V3_Drainage Report-Final_comments.pdf Markup Summary

Final Drainage Letter for Flying Horse Foundation

HR Green Project No: 2502010

SF256 & PPR 256

DETENTION BASIN OUTLET STRUCTURE DESIGN

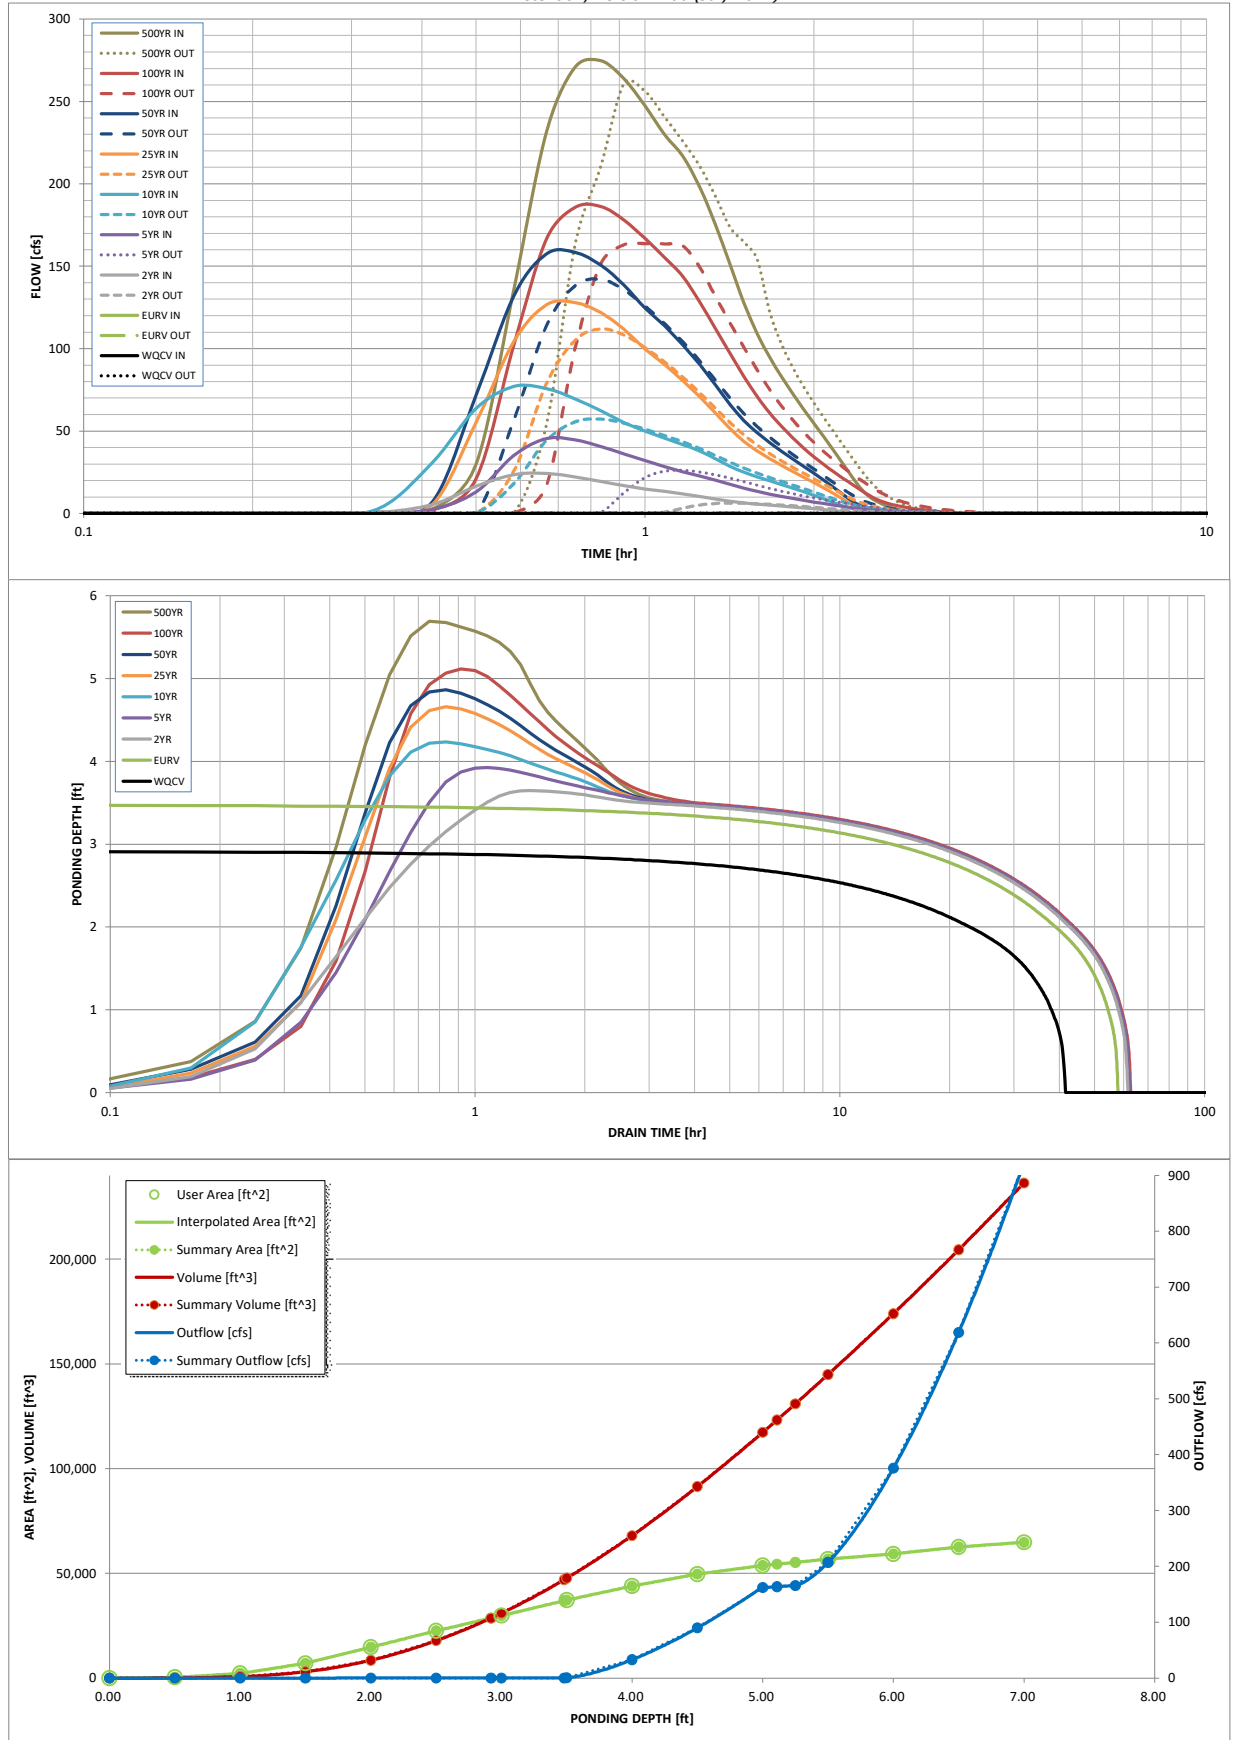
Please clarify what you mean by N/A. If it's N/A, then why have any inputs here? I think I'm just not understanding what you mean.

Updated Pond Outlet Structure Details for Flying Horse North Filing No. 4 Pond A

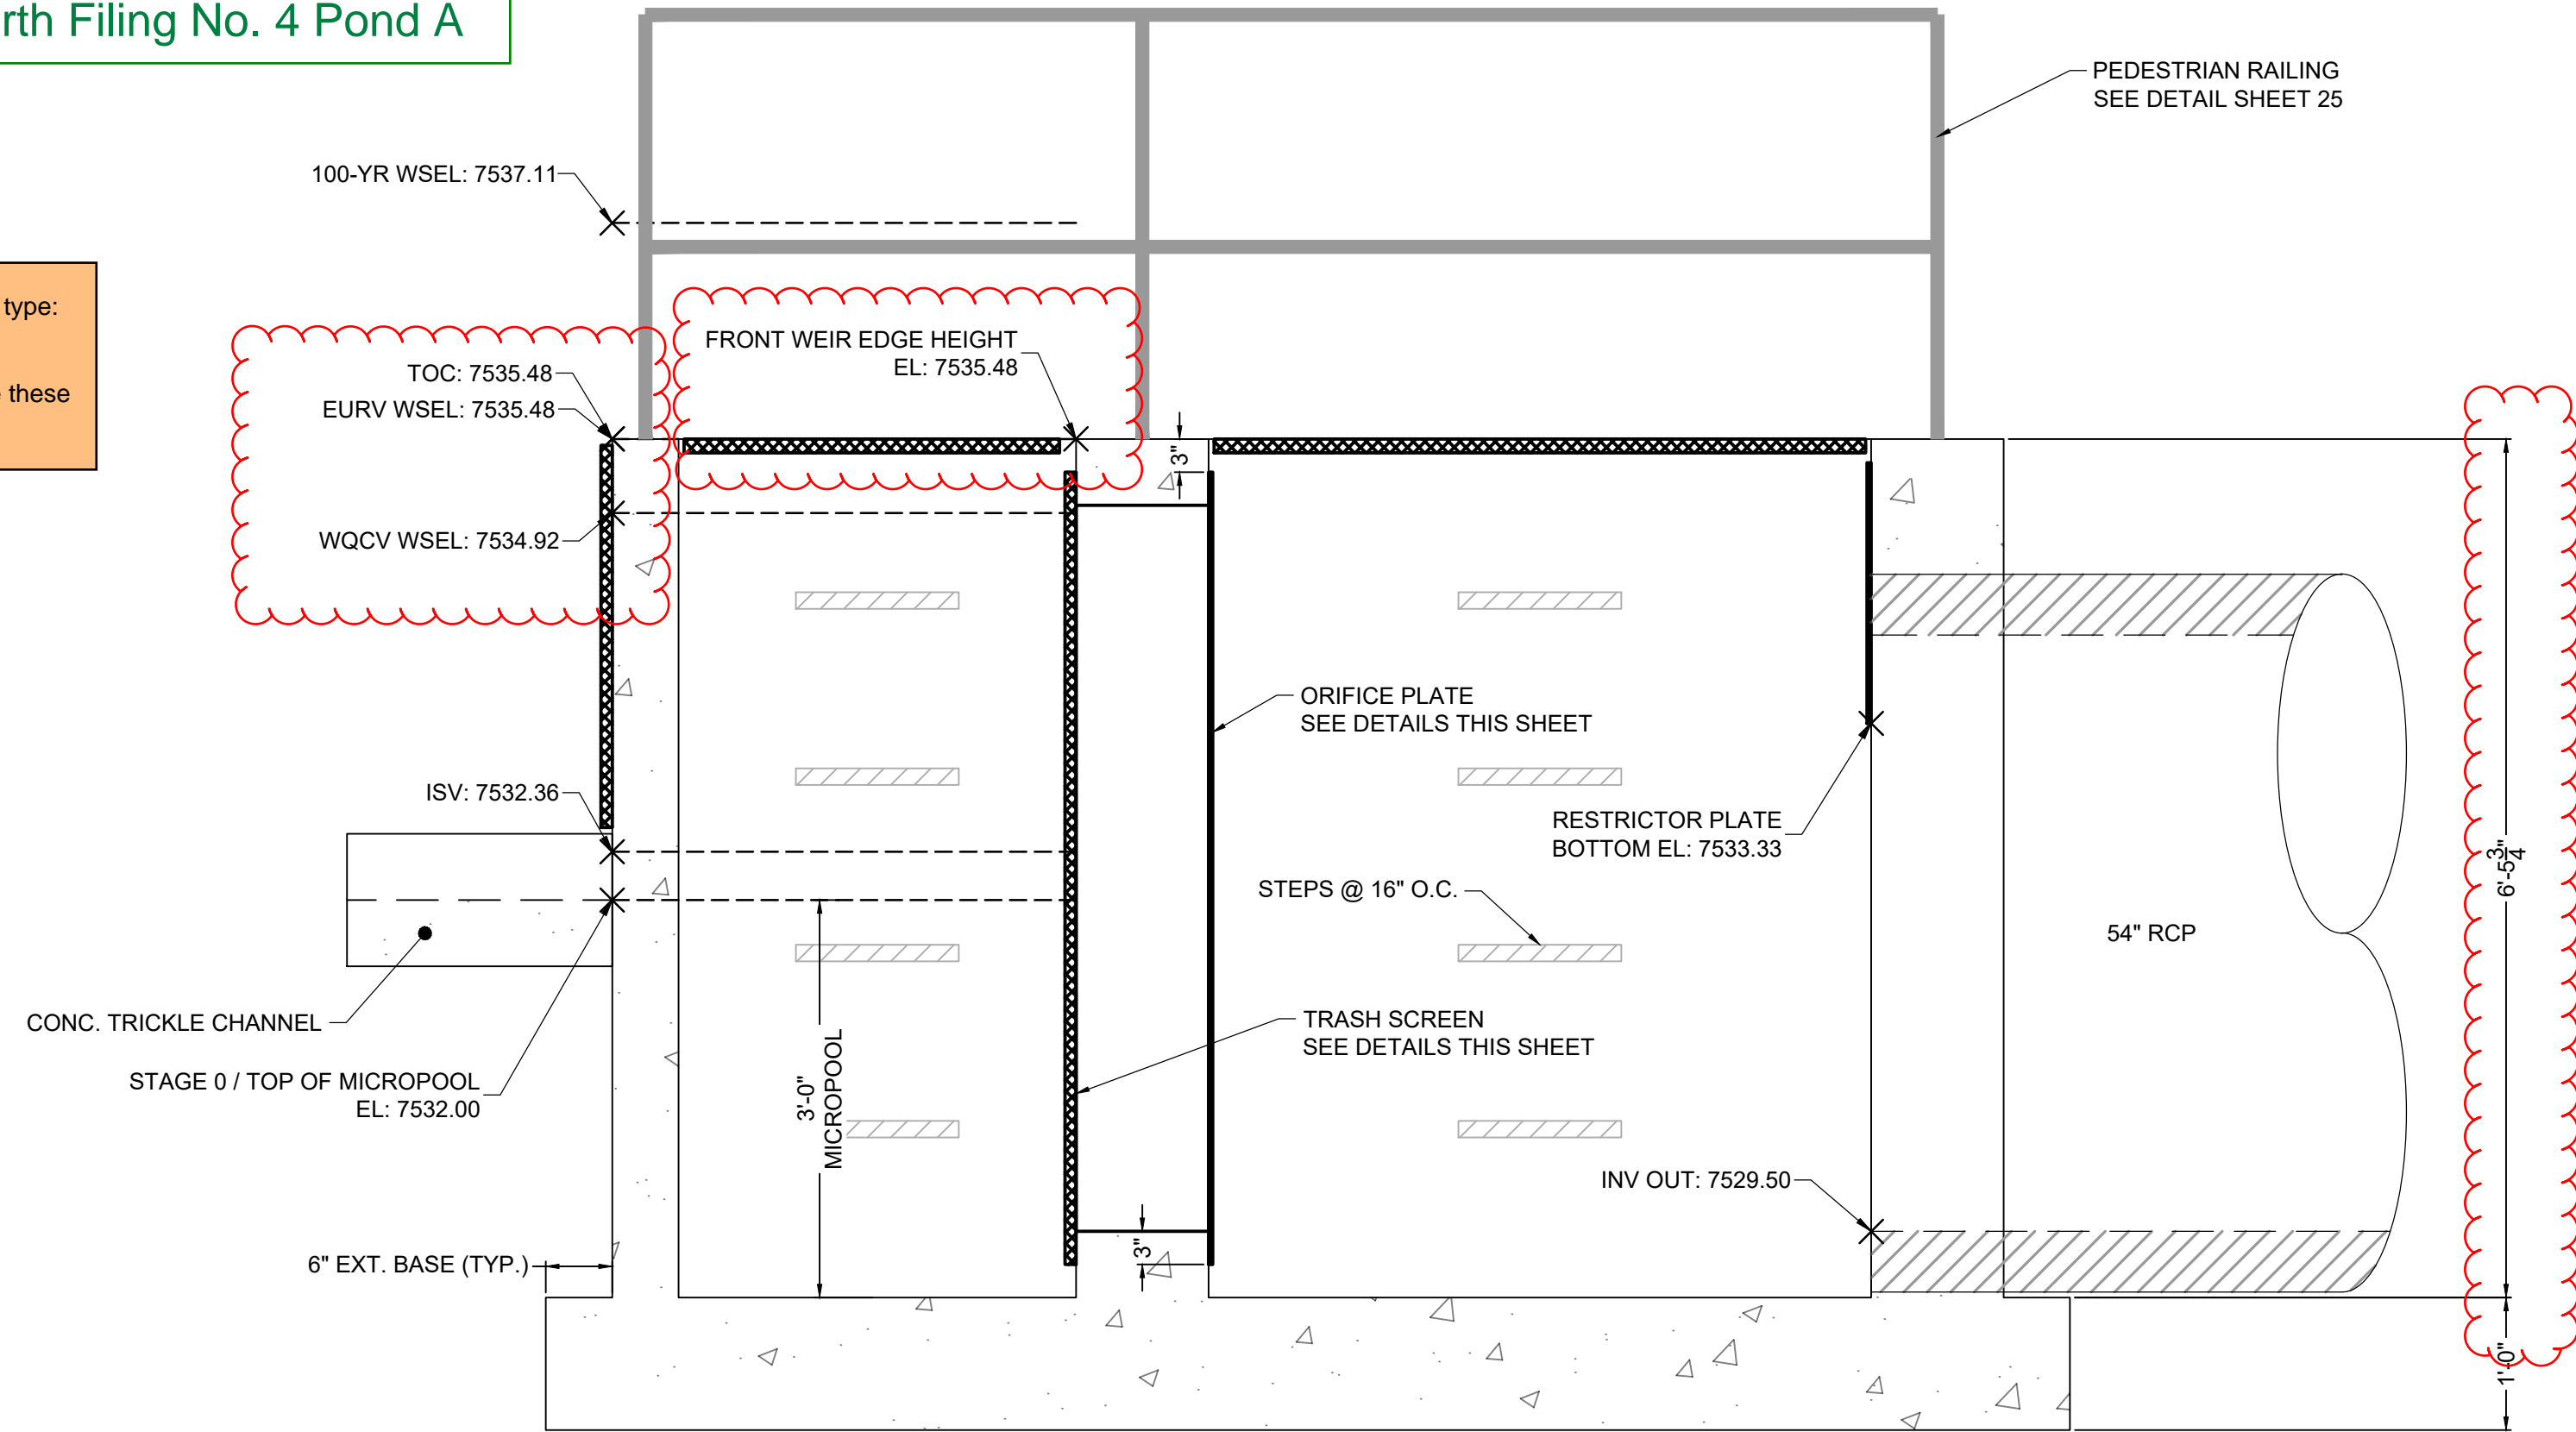
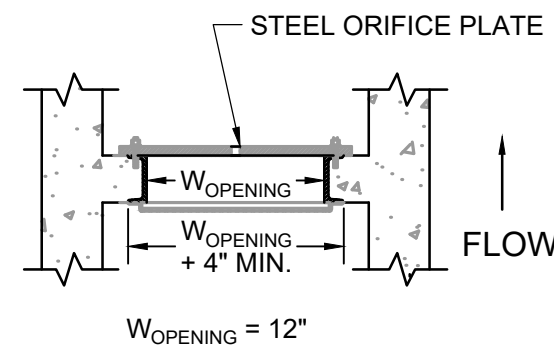
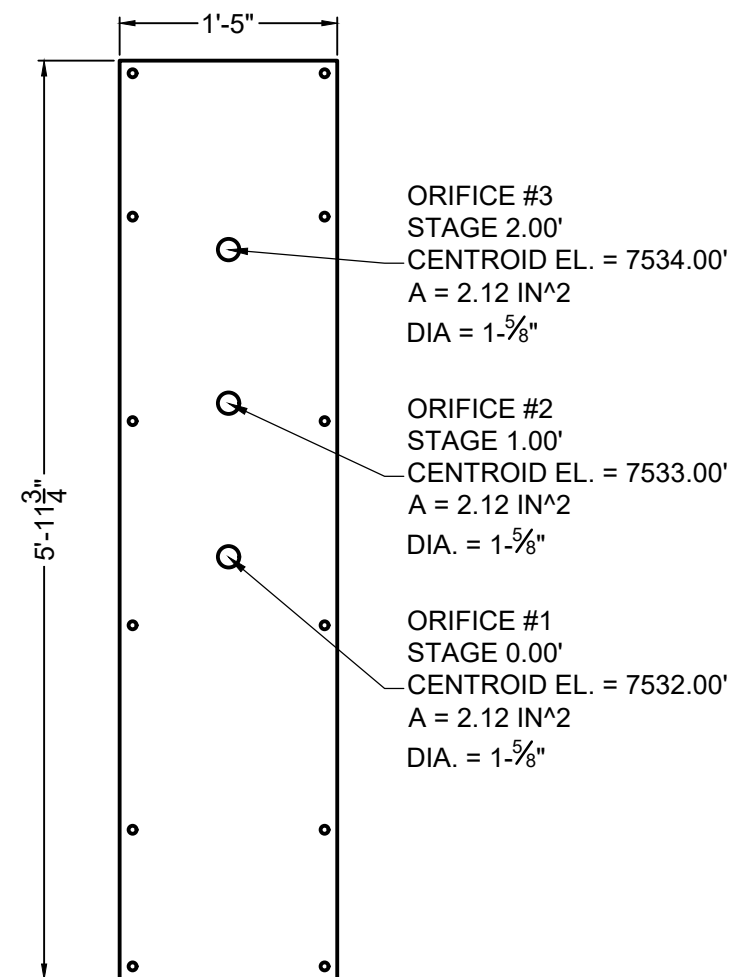
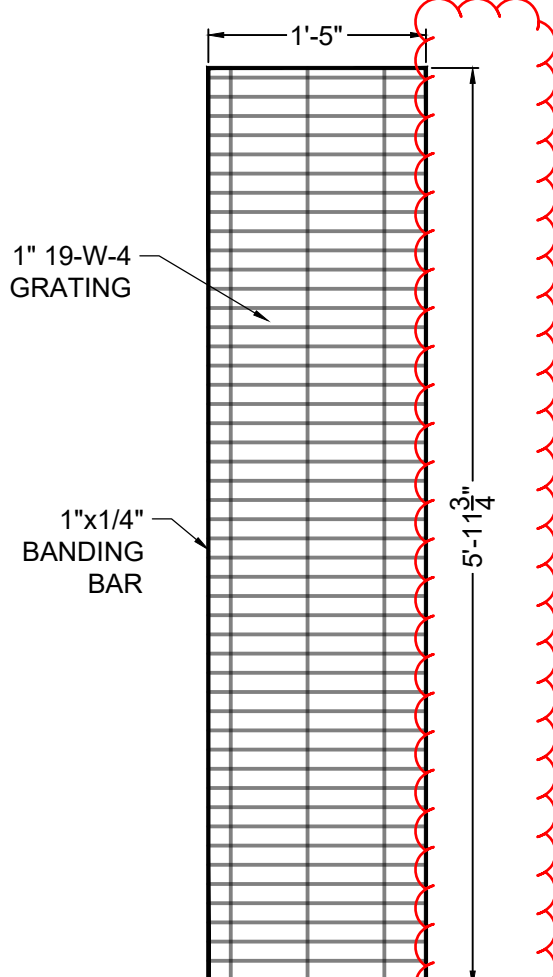
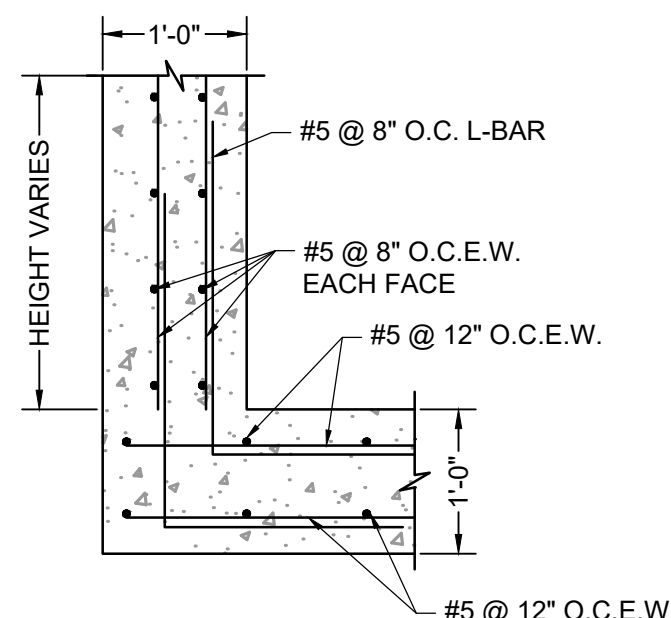
For all projects, construction drawing sheets need to be uploaded to EDARP with a more appropriate document type: either with CDs or GEC plan.
So since this project doesn't have CDs, you can include these outlet structure modification sheets with the GEC Plan.
